Bulletin Type.....: Safety Recall

Bulletin No.....: TS-S130

Bulletin Name.....: Nozzle Replacement

Subject:Firetrace fire suppression system nozzle replacement

FOR DOT SYSTEMS (SYSTEMS USING NOZZLE P/N 500002 AS SHOWN ABOVE):

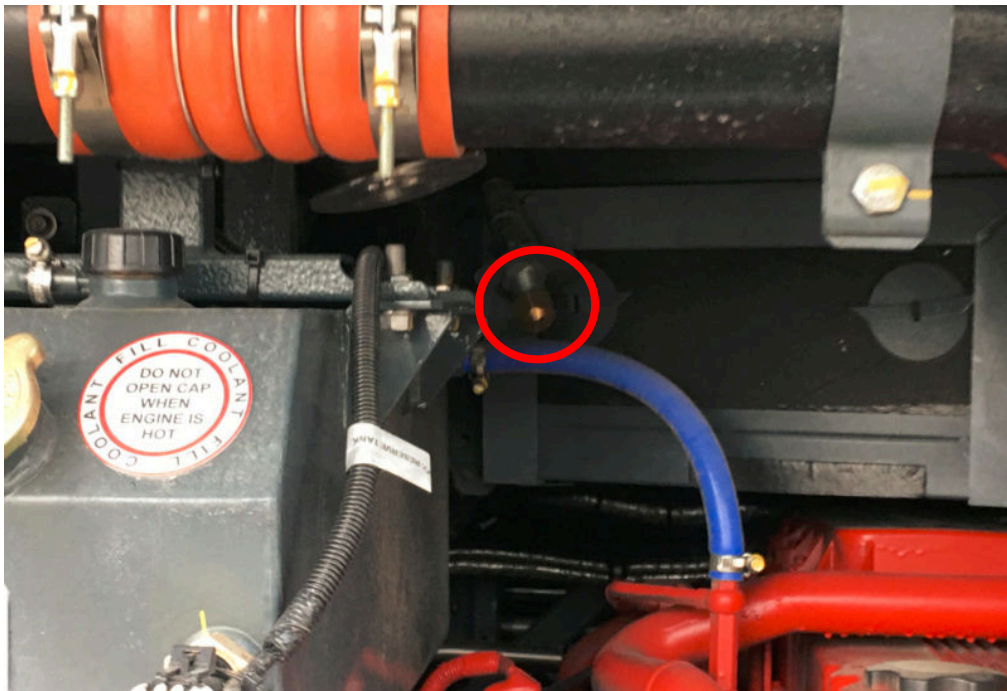
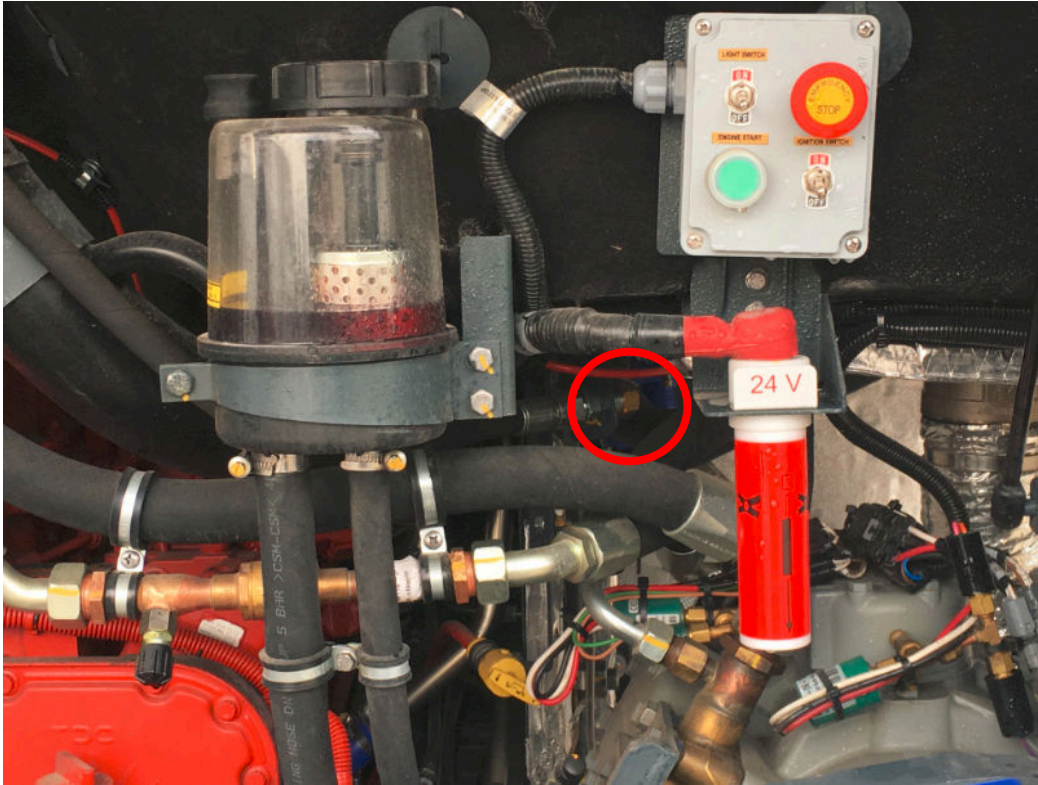
The kit contains either 2 or 4 nozzles per the system design (no adapters are required).

1. Remove the existing nozzle with a spanner (wrench) to remove the nozzle from the fitting whilst clamping the fitting to avoid disturbing other connections. Discard the nozzle.
2. (If applicable) Remove and RETAIN the rubber cap on the nozzle.
3. Install the nozzle using PTFE tape on the male connection. Use care to secure the fitting while tightening the nozzle on to the fitting, hand tight plus 1.5 turns.
4. (If applicable) The nozzle cap may then be reinstalled by first sliding the tether over the nozzle and then placing the cap in place over the nozzle.
